Product Change Notification

Change Notification #: 112904 - 00
Change Title: Intel® Server System P4308IP4LHJC
PCN 112904-00, Product Design
Update BIOS/ME/BMC/FRUSDR Firmware,
Stand-off and Power Distribution Board
Cable Change
Date of Publication: February 27, 2014

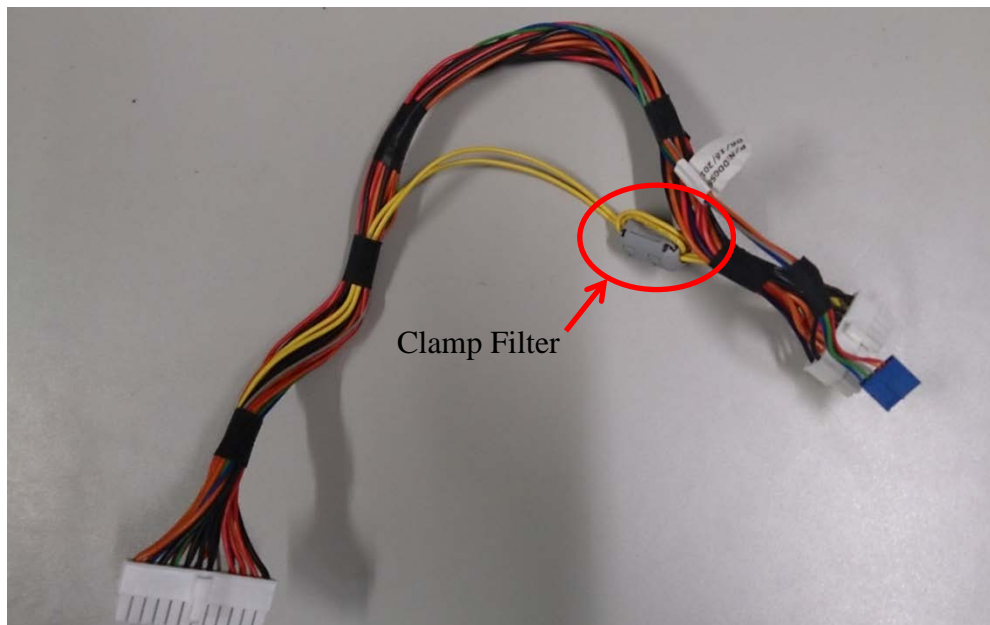
- e) Remove the plastic stand-off depicted below from the system accessory kit, and install the plastic stand-off on the server board.
